DOCUMENT 00 90 00
ADDENDUM

ADDENDUM NO. [2] **Date: September 23, 2021**

RE: LA FARGE SCHOOL DISTRICT
ADDITION AND RENOVATION
301 W. ADAMS STREET
LA FARGE, WI 54639
HSR Project 19041-1

FROM: HSR Associates, Inc
100 Milwaukee Street
La Crosse, WI 54603
(608) 784-1830

1 ENLARGED BOILER ROOM PLAN
1/2" = 1'-0"

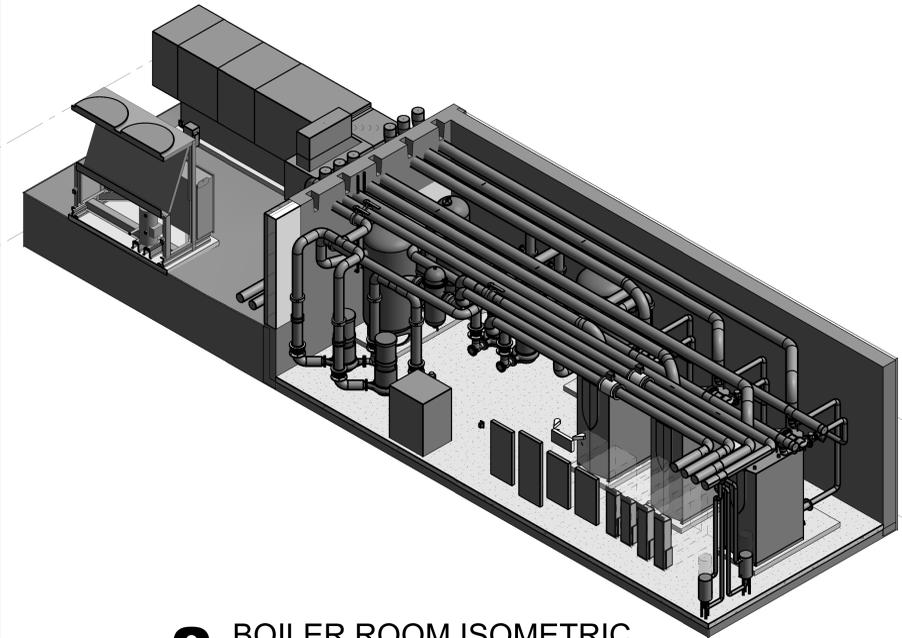
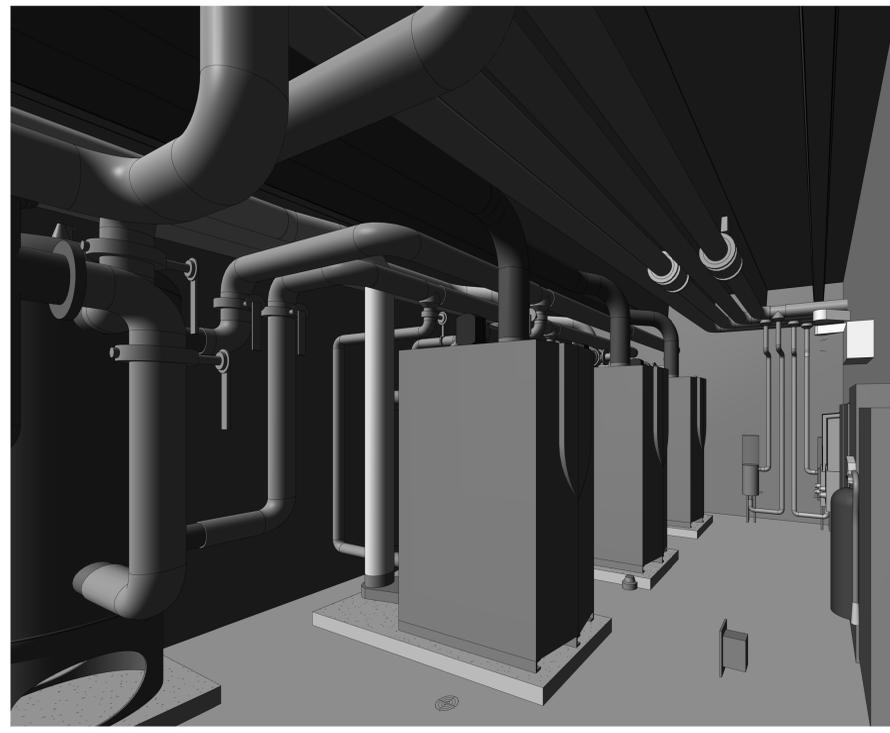
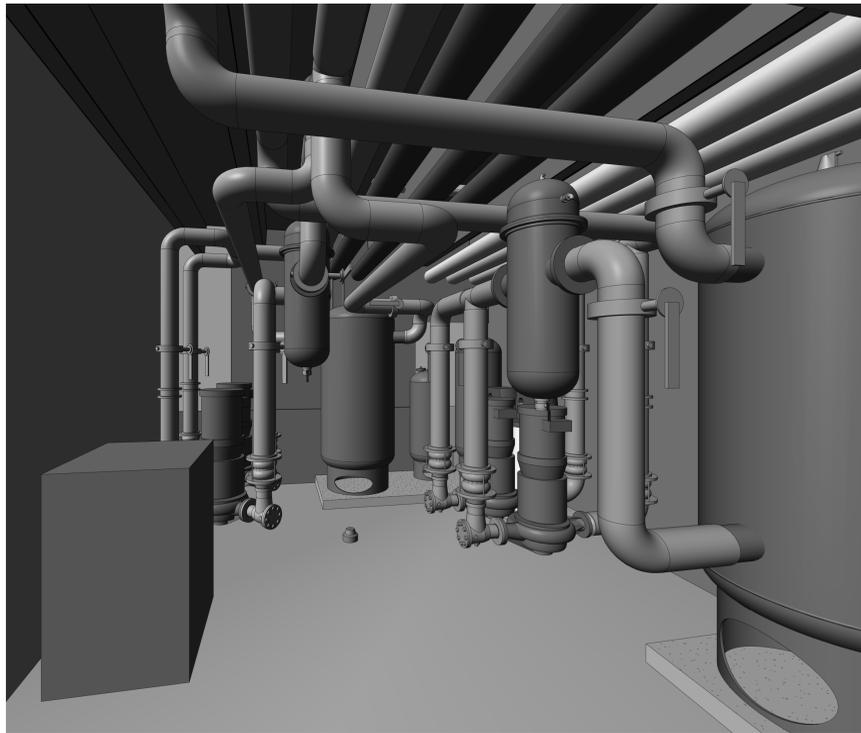
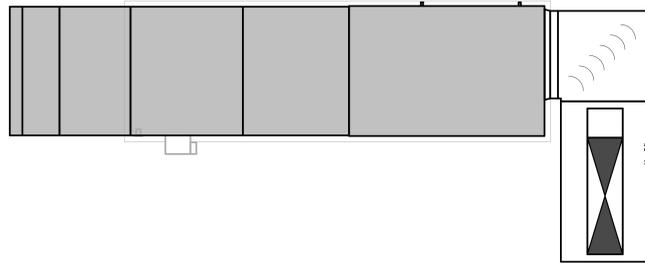
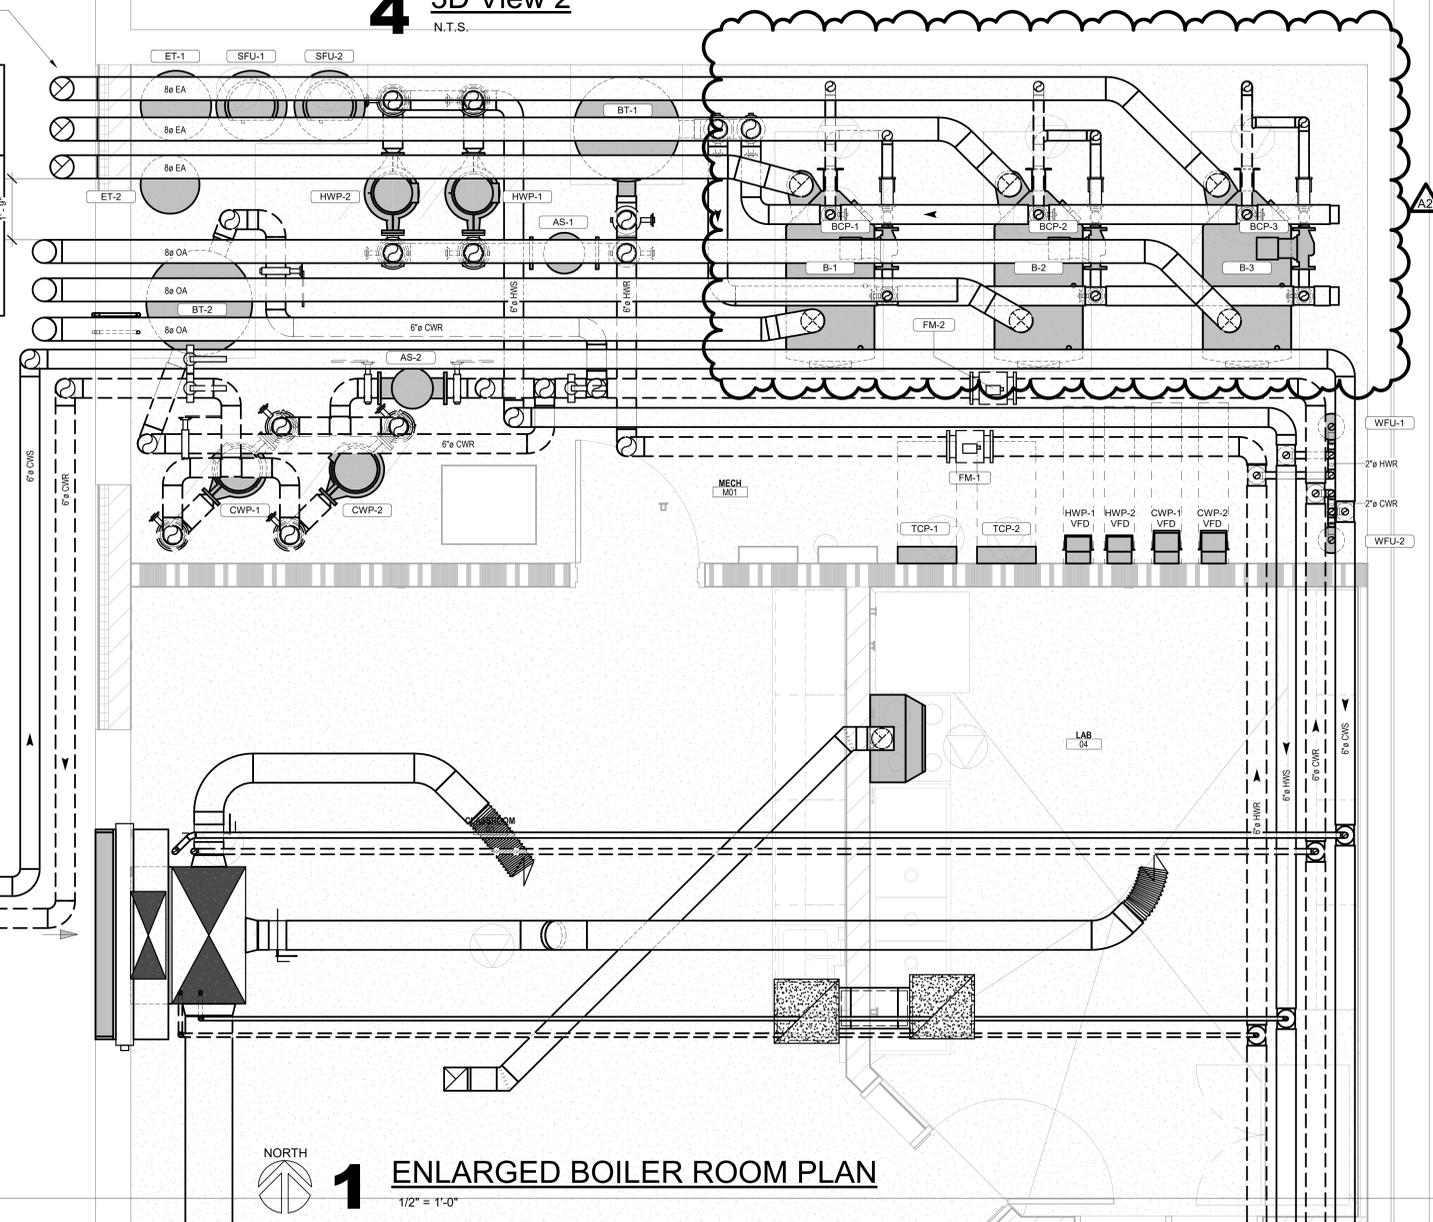
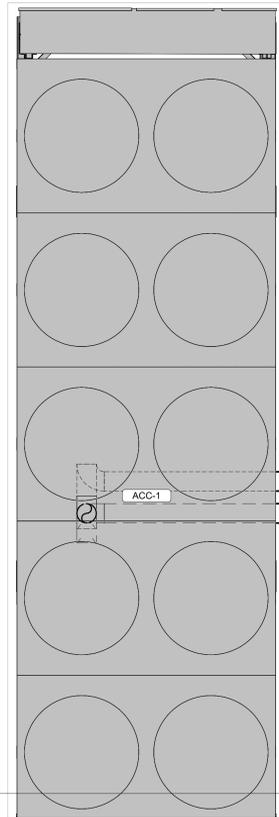
- a. Replace sheet with new sheet
19. Sheet M200 ENLARGED PLANS 30 x 42 attached hereto
 - a. Revised boiler layout to include update basis of design boilers (dual fuel).

1 LOWER LEVEL ELEC. DEMO PLAN - SEG A
1/8" = 1'-0"

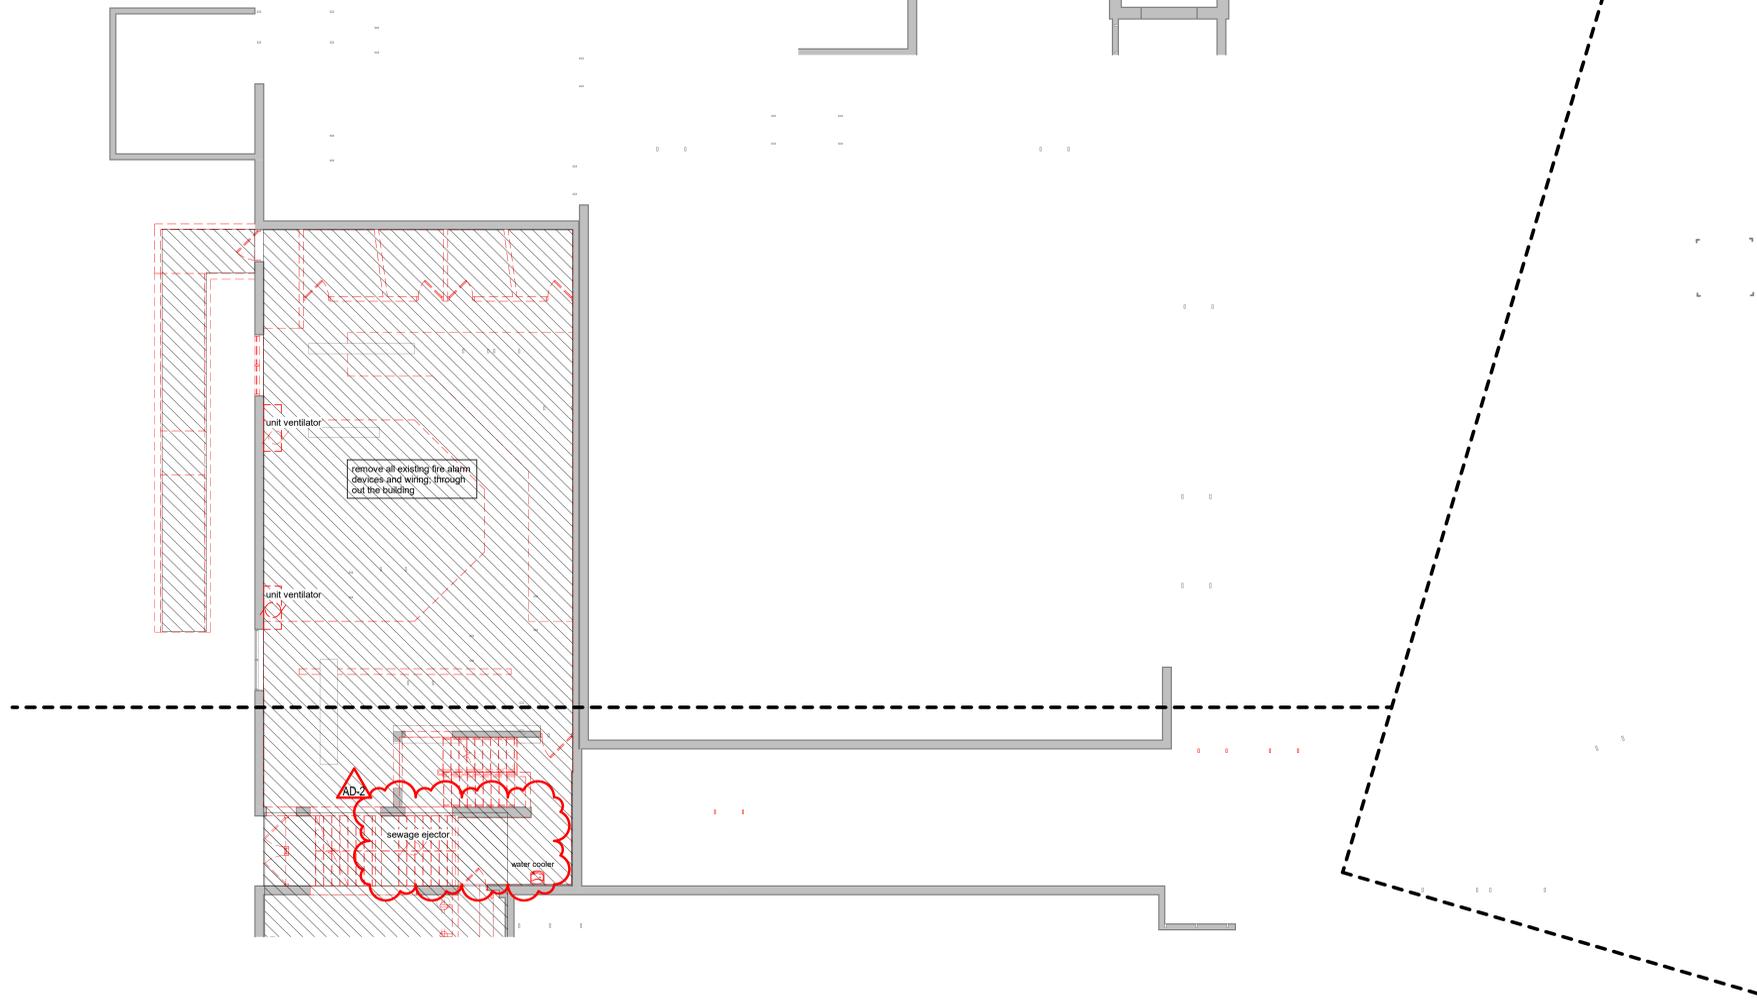
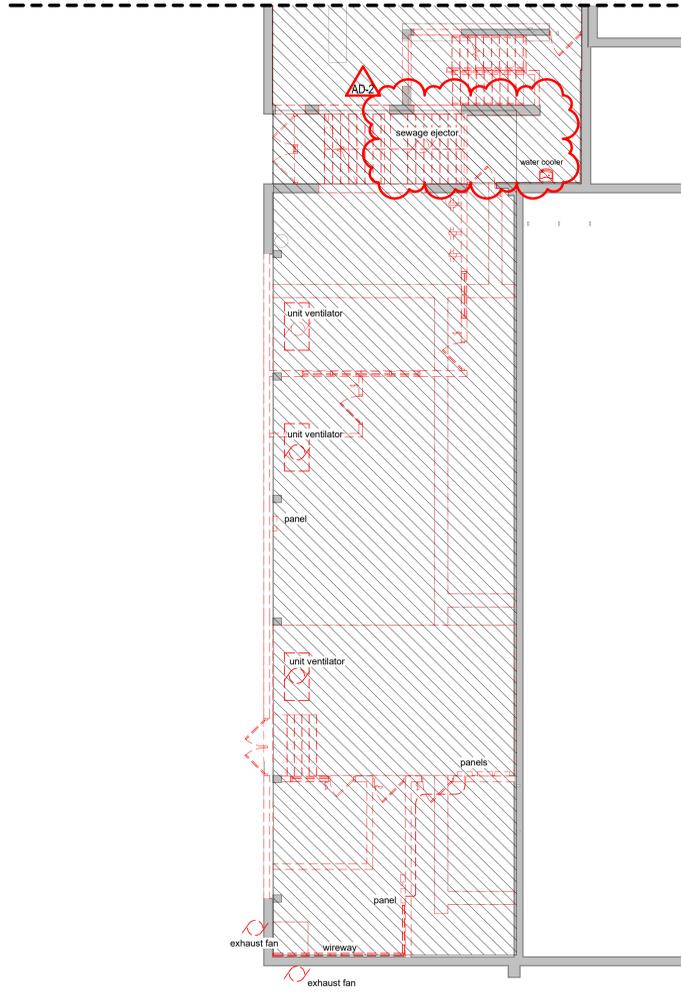
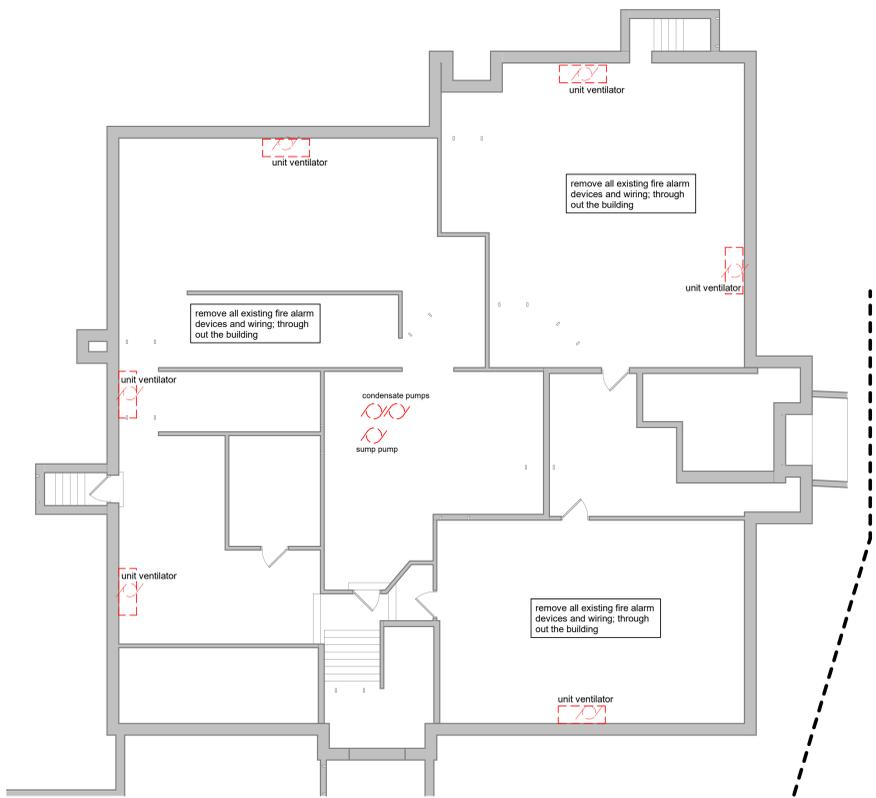
22. Sheet E090 LOWER LEVEL ELEC. DEMO PLANS SEGEMENT A & B 30 x 42 attached hereto
 - a. Added equipment to be removed
23. Sheet E092 – FIRST FLOOR ELEC. DEMO PLAN – SEG.B 30 x 42 attached hereto

E092

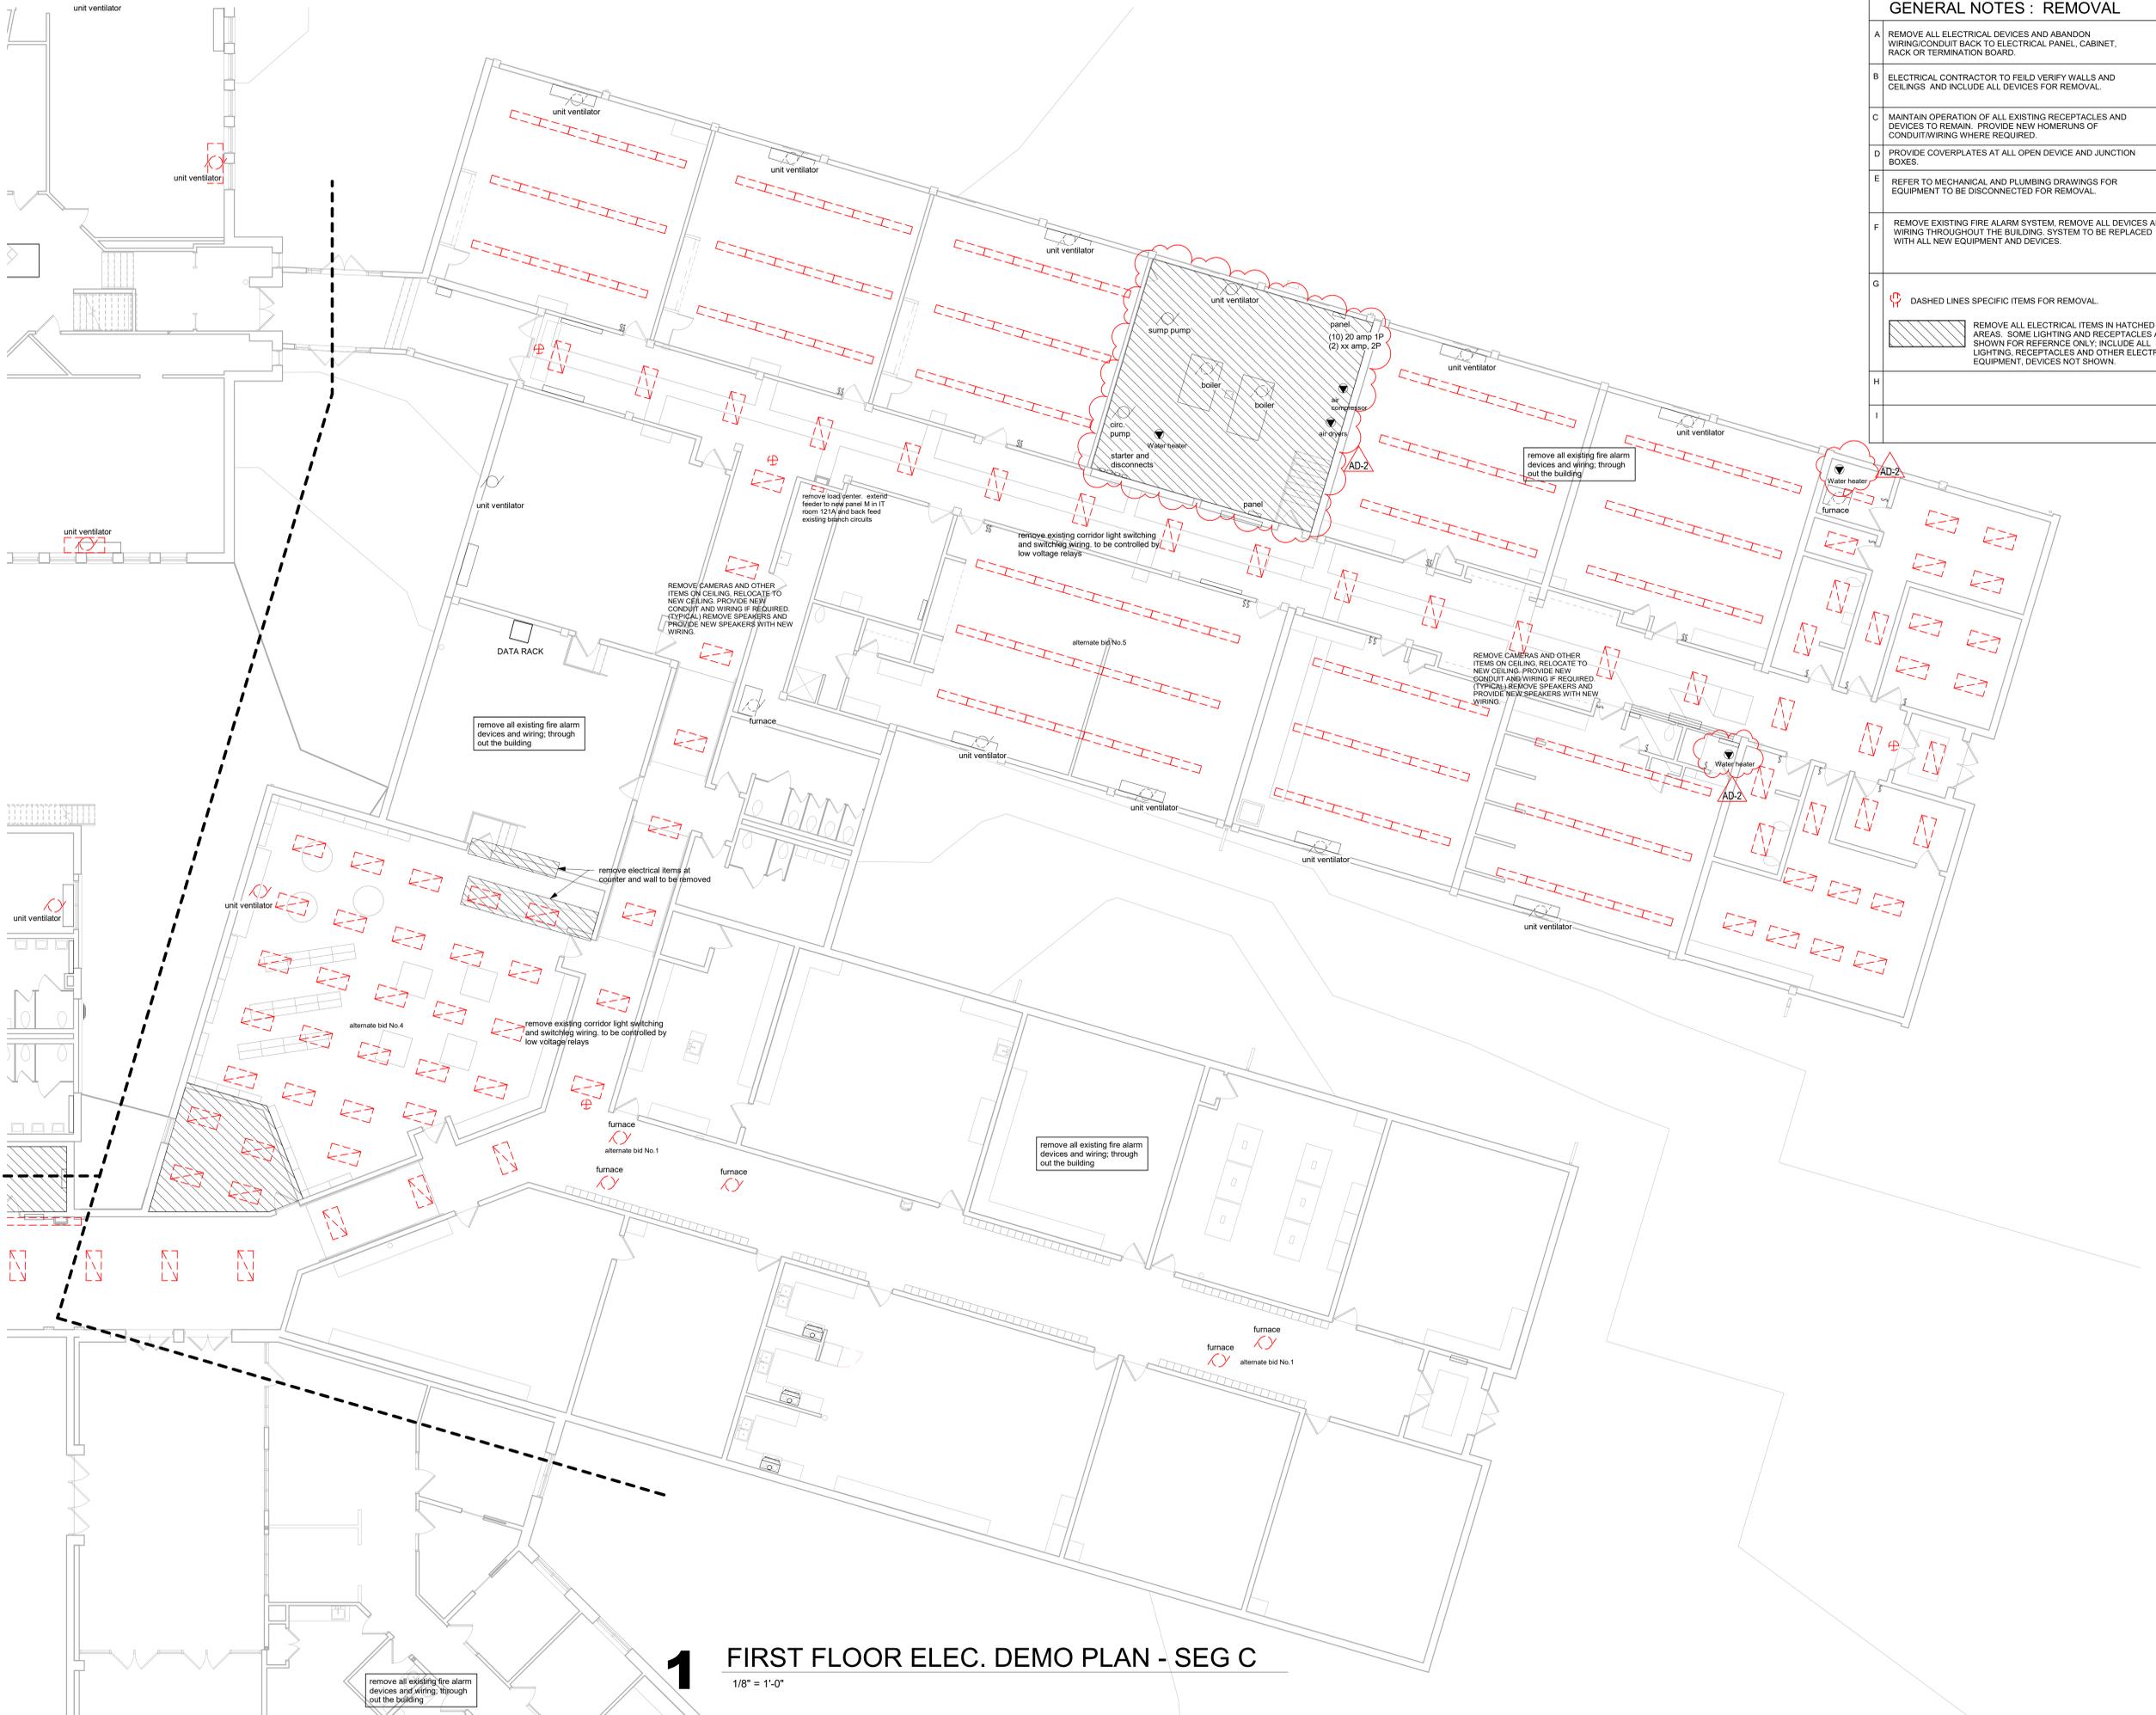
- a. Added areas of demolition.
24. Sheet E093 – FIRST FLOOR ELEC. DEMO PLAN – SEG. C 30 x 42 attached hereto
 - a. Added areas of demolition.
25. Sheet E100- LOWER LEVEL – SEGMENT A & B 30 x 42 attached hereto
